TMJ Product Change Notice PCN Tracking Number: TMJ-PP-1478

Subject: Addition of FPC maker for touch panel

FPC appearance

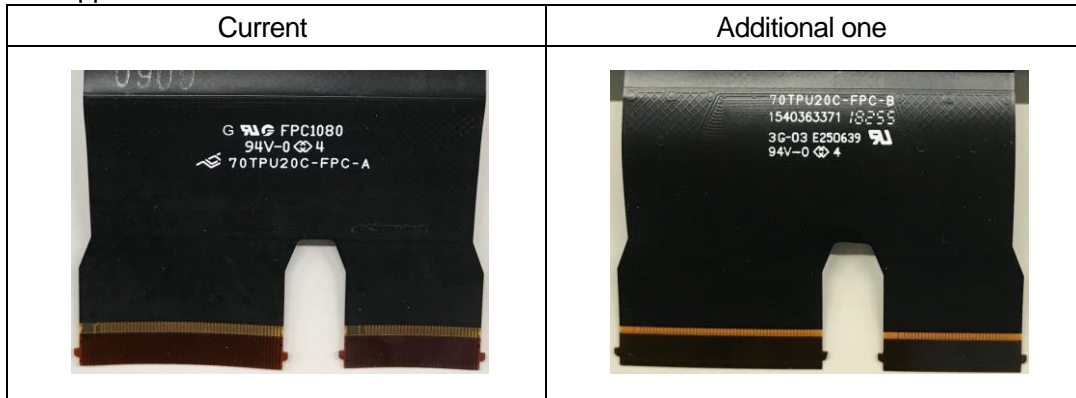
In order to get stable procurement of FPC for touch panel, FPC made by maker B will be added.

Current : FPC made by maker A
 After change : FPC made by maker A and FPC made by maker B

FPC made by maker A and FPC made by maker B are compatible one except for the printing on the FPC and the color of the terminal reinforcement plate. There is no difference in the performance of FPCs in terms of size, pin connection, pin pitch, material, flame retardance and so on. Therefore you can use same touch panel controller as current one.
